City of Portland
 Development Review Application
 Planning Division Transmittal Form

Application Number: 2015-204 **Application Date:** 11/16/2015
CBL: 234 A001001 **Application Type:** Level II Site Plan
Applicant: City of Portland Public Services Dept. /John Emerson
Project Name: Water Resources Modular Office Space
Address: 109 District Road
Project Description: 2 pre-fabricated office buildings.
Zoning: IM

Project Name: **Installation of Modular Offices near existing storage building**
Project ID: #2015-204
Address: 109 District Road CBL: 234-A-1
Applicant: John Emerson, Department of Public Works, City of Portland
Planner: Jean Fraser

TYPICAL RAMP DETAIL

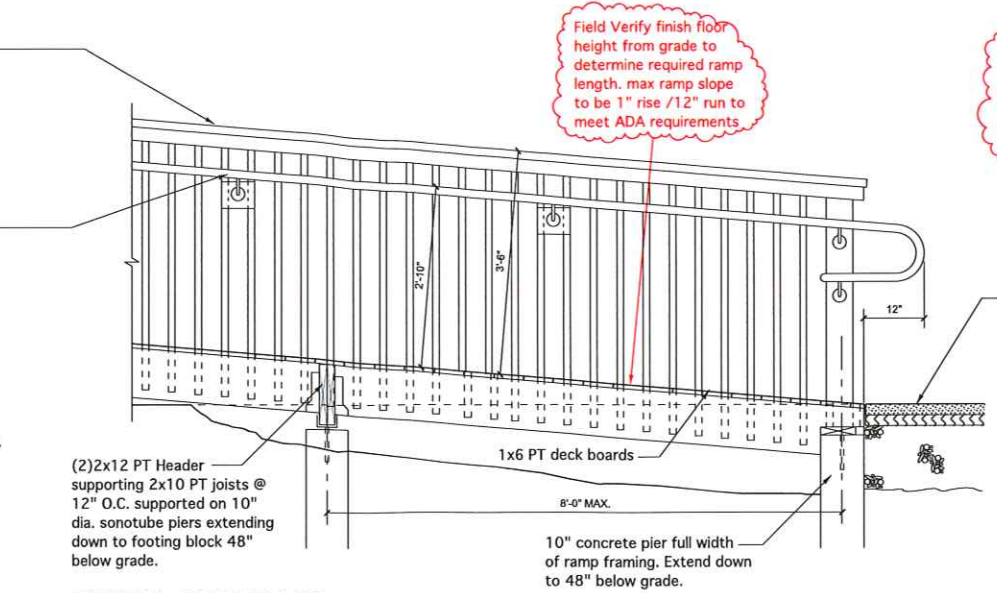
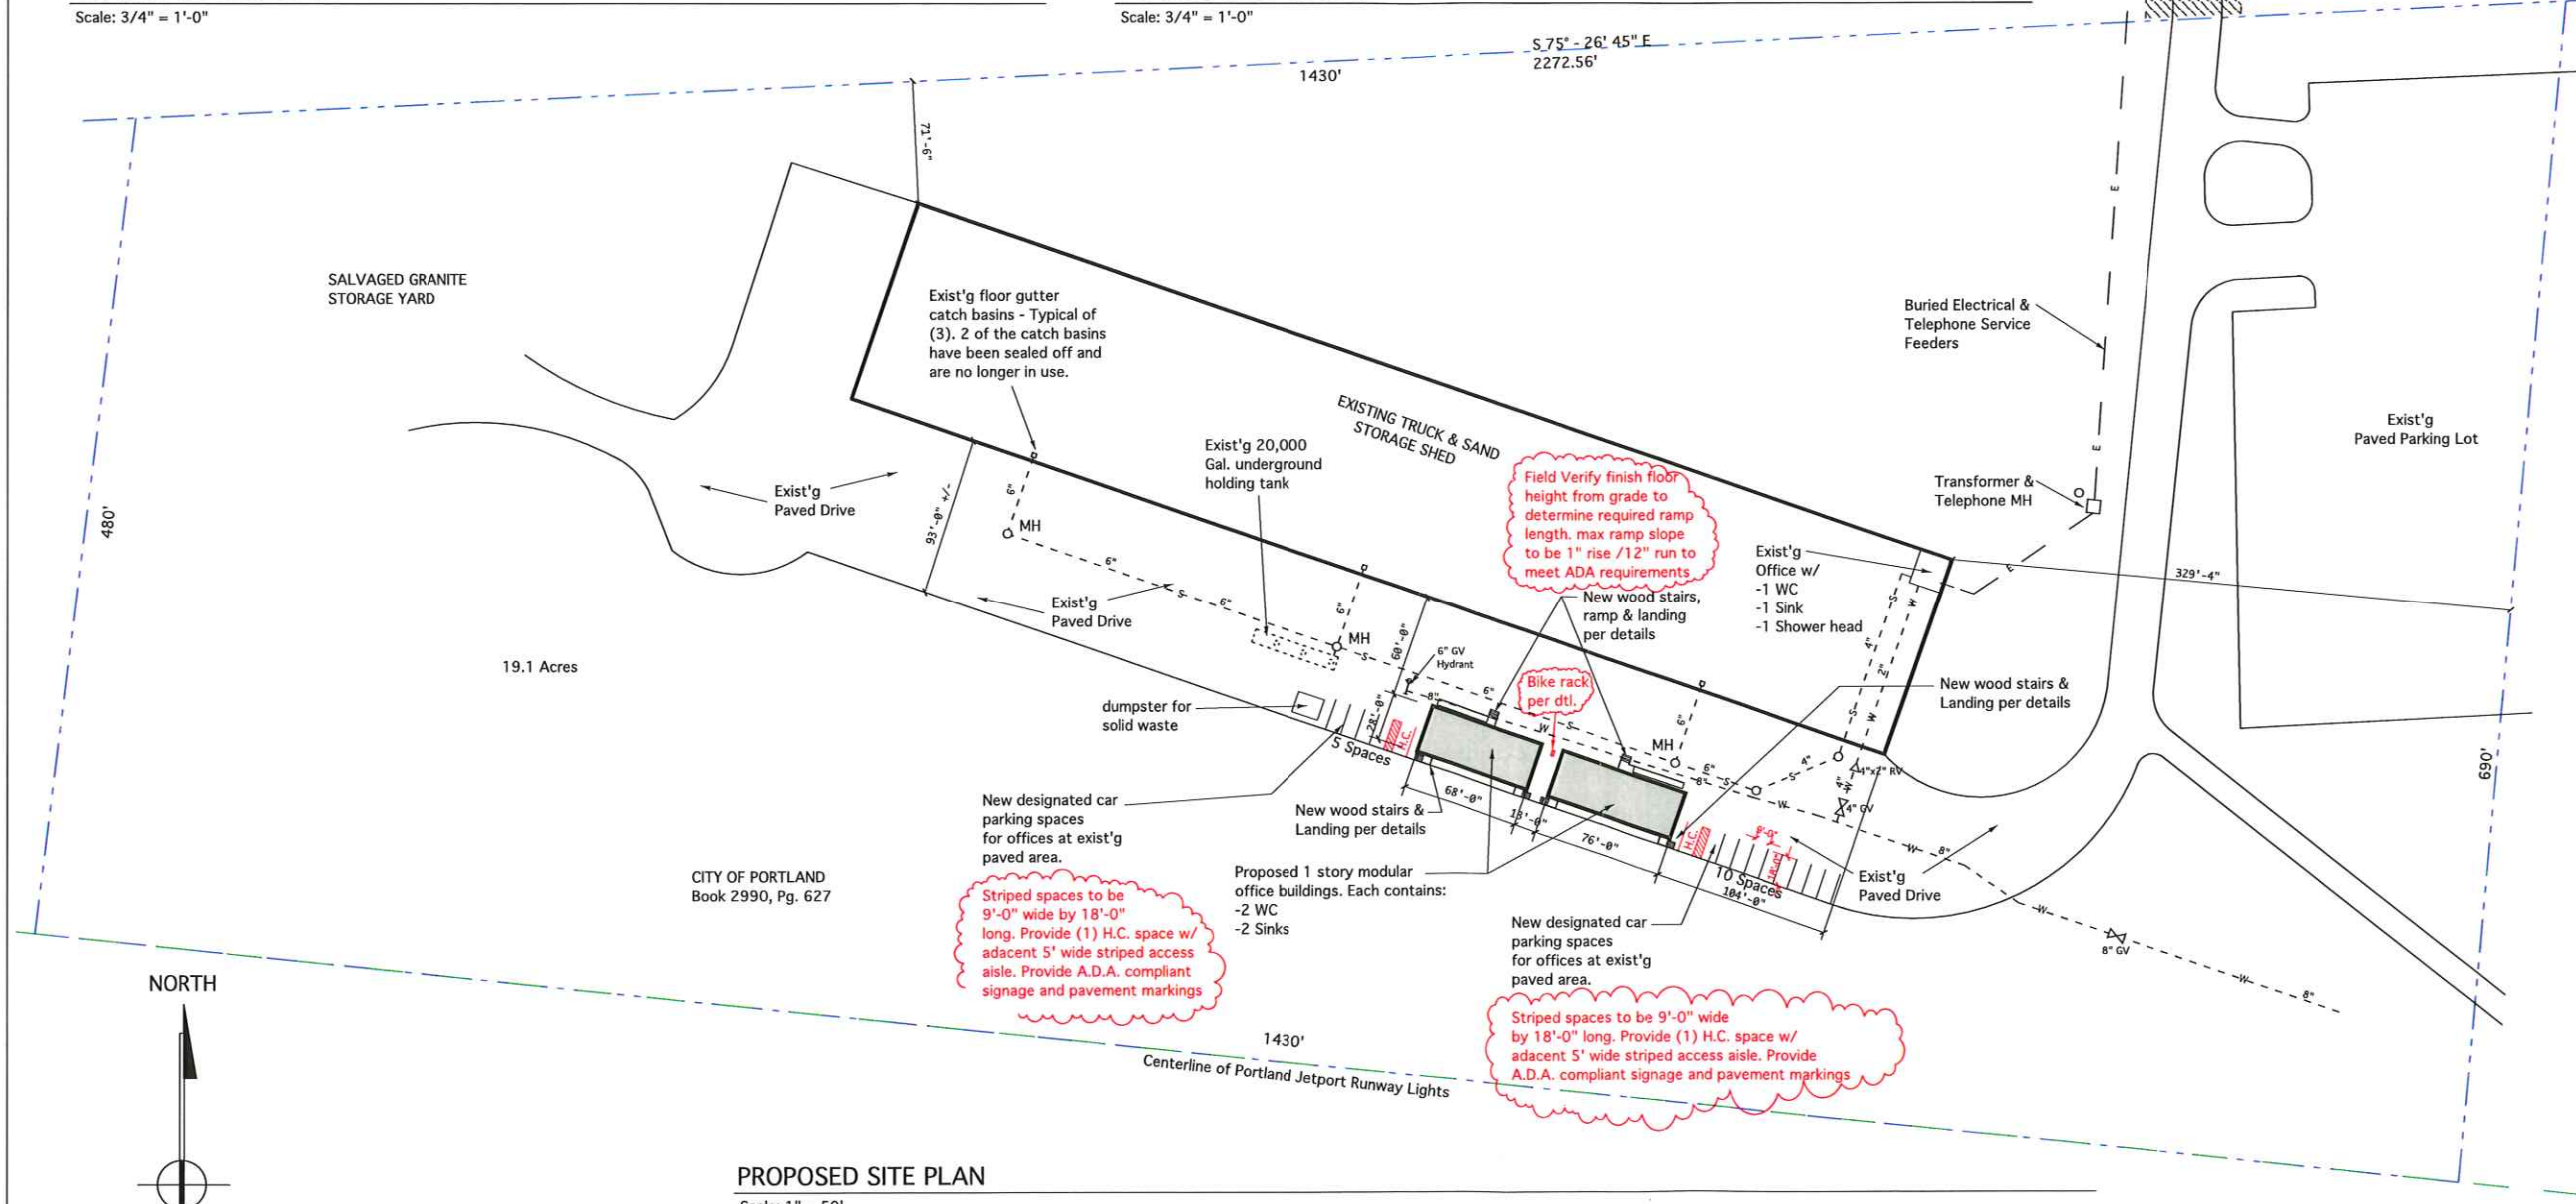
Thanks for your message regarding the site plan review for above referenced project. Yes, the intent of the ramps is to meet A.D.A. requirements. I did not detail the exact ramp length because Iâ€™m not certain of the floor elevation above grade but I should have designated in my detail that the ramp slope will be a maximum slope of 1â€ of rise per 12â€ of run.

I will also add a note for a bike rack. You also mentioned the lighting in your message and I presume the issue is that the exterior porch lights at the doors donâ€™t meet the Cityâ€™s cut-off requirements(?). The lights are provided by the modular manufacturer but I can see if an alternate could be provided. Cut off didnâ€™t seem to be a big concern as the whole area is so isolated from abutters and streets and with the equipment traffic they have ongoing at the site there are already building mounted lights on the existing shed that make much more of an impact.

Field Verify finish floor height from grade to determine required ramp length. max ramp slope to be 1" rise / 12" run to meet ADA requirements

Steel tube bike rack with black factory paint finish set in concrete foundations. Rack to be model # R-B212 as manufactured by Reliance Foundry or approved equal
